The New Bondway Proposal in its Cluster Context

Old Bondway, as refused by the Secretary of State (9 February 2011) compared with New Bondway proposal [extracts in bold from the Secretary of State Decision Letter about Old Bondway, *italic KOVF commentary*]:

Extract of English Heritage views 26 February 2014

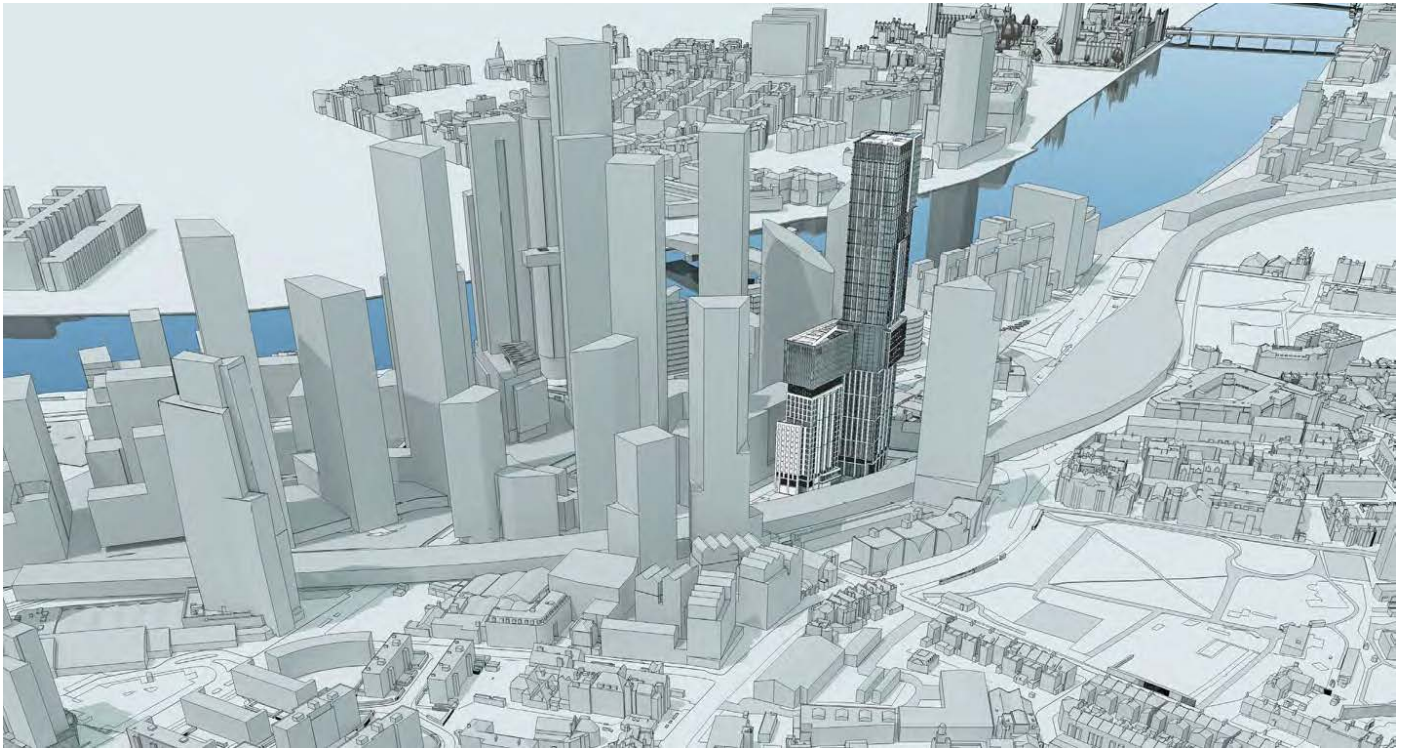
The Old Proposal:

Then height 149m above ground level (AGL):

Then 1513.5 sqm public open space

COMPARISON WITH FORMER PROPOSALS IN THE SITE

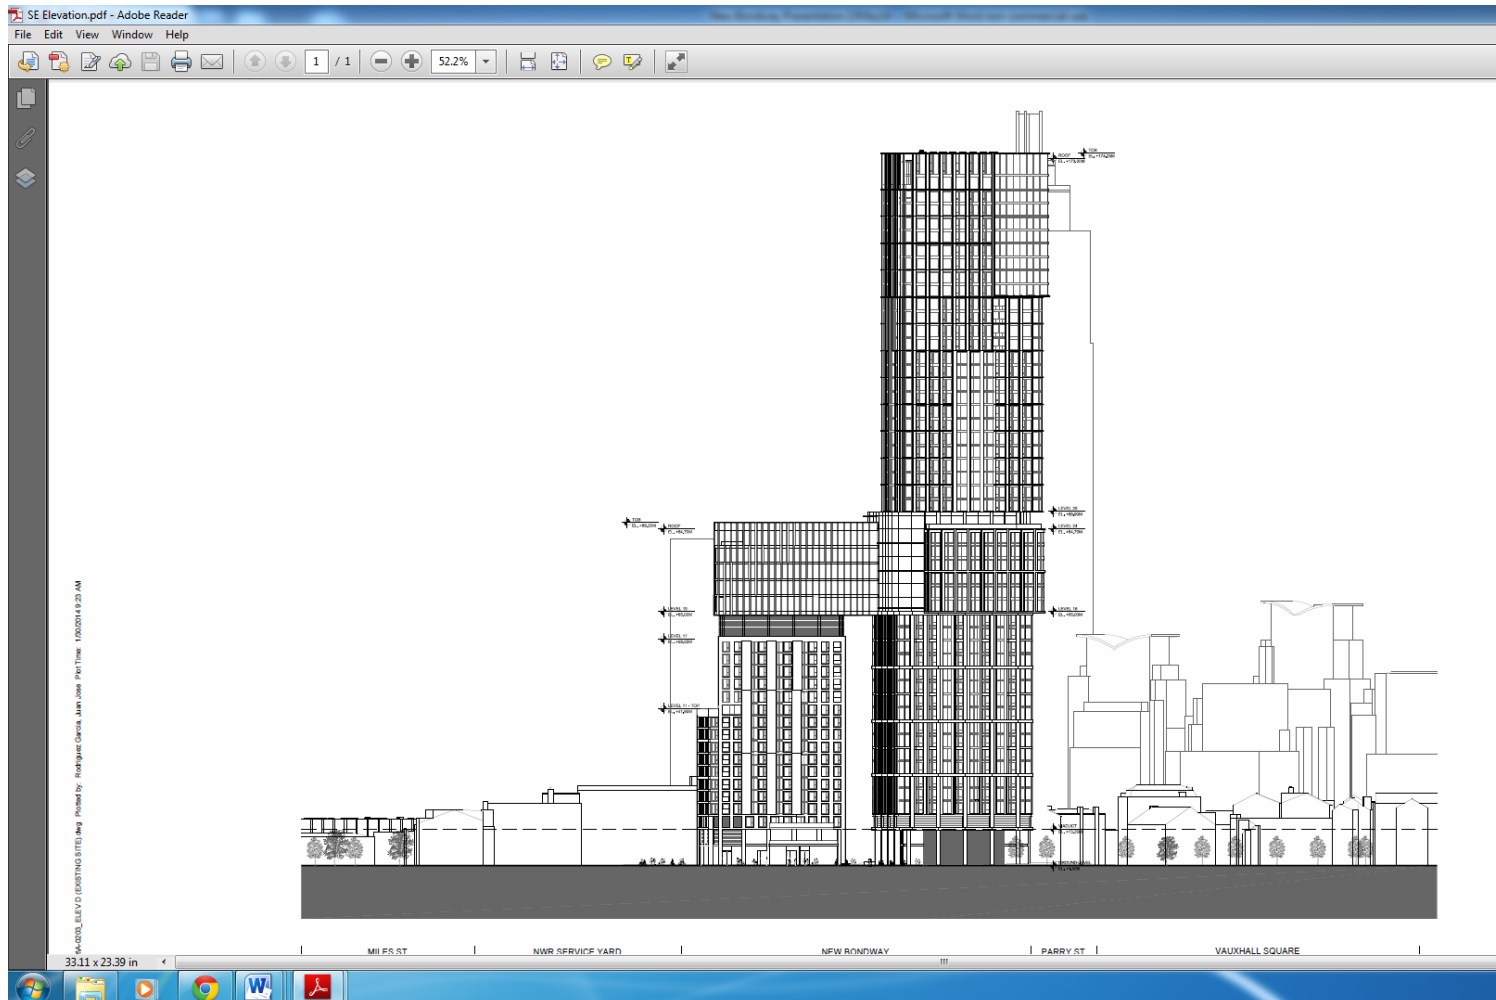
The New Proposal:

And **now** 170m AGL (an extra seven storeys):

and now 1542.8 sqm public open space:

The New Proposal increase the area of public realm/gathering space around the building from 1516 sqm (Old Proposal) to 1543 sqm, an increase of 29 sqm.
